RE: PETITIONS COMMITTEE 23.02.16
PETITION SUBMITTED BY MR MERVYN LLOYD JONES
THE BRIMMON OAK TREE
A483/A489 NEWTOWN BYPASS

With regards to the above joint petition (P-04-658) that was submitted to the WAG petitions committee on 2nd October 2015 and the recent reply from Edwina Harts office. (EH/00327/16)

THE BRIMMON OAK TREE A483/489 NEWTOWN BYPASS

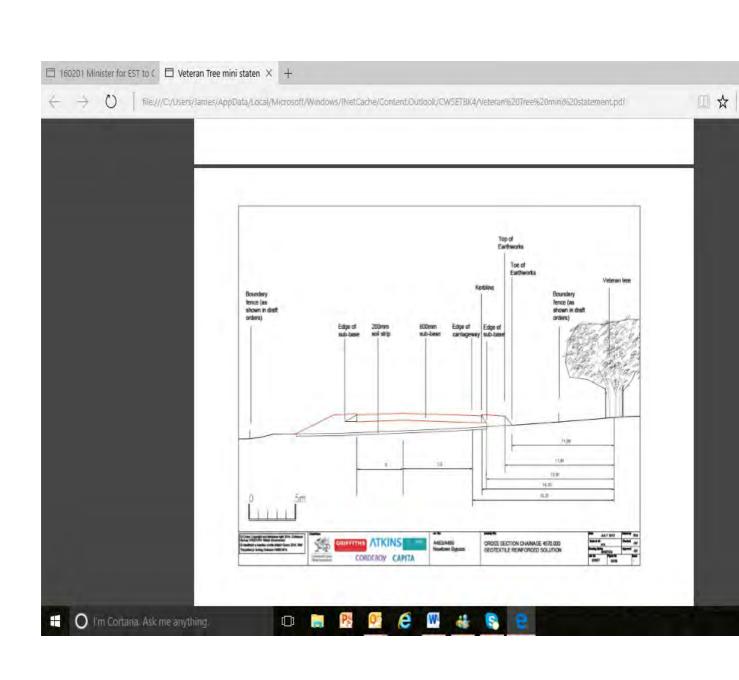
The Welsh Government report on the tree carried out by Jerry Ross (B.Sc. F.Arbor.A Arboricultural Association Registered Consultant) proposed the use of a 'geotextile reinforced solution' to ensure any compacting ground works were moved further away from the tree. This would obviously be of a certain benefit but I do not feel that the distance is sufficient and that the tree could still be endangered. The proposed solution suggested that the edge of the carriageway would be 15.31 metres from the centre of the tree. However, the kerb line would only be 14.31 metres from the centre of the tree and the toe of the earthworks would be 11.06 metres away. I understand that there was a suggestion not to have any soil stripping or ground excavation works but from the diagram included with the report (attached for your reference), even the subbase of the road would be less than 14 metres from the tree.

To add to this, the proposed fence line is a mere 5 to 6 metres from the tree. The fencing along the scheme is going to be badger proof fencing which requires a mesh to be buried into the ground. With the fence only being 5 to 6 metres from the centre of the tree, a critical part of the root system will be endangered.

As part of the inquiry process, I had instructed the land agent acting on my behalf to prepare and submit an alternative route. The route proposed simply moved the carriageway no more than 20 metres north and consequently further away from the tree. There was no major realignment to the initial route. The WAG simply asked for no more than a sketch map of our alternative route and as we are not structural engineers, that it what was submitted. We were of course open to negotiation and had a realistic approach that a compromise could have been met. However, it would appear the design team took a very literal approach to our proposal and rejected it on the grounds of cost. I would have been very happy to discuss a suitable alternative with the designers. The ground the other side of the road is in my ownership so no other parties would have been affected. Even a realignment of 10 metres north would save this veteran oak tree for generations to come. I understand the restrictions of the gas pipe running to the north of the scheme but I fully believe that there is room to move the carriageway in order to protect the tree.
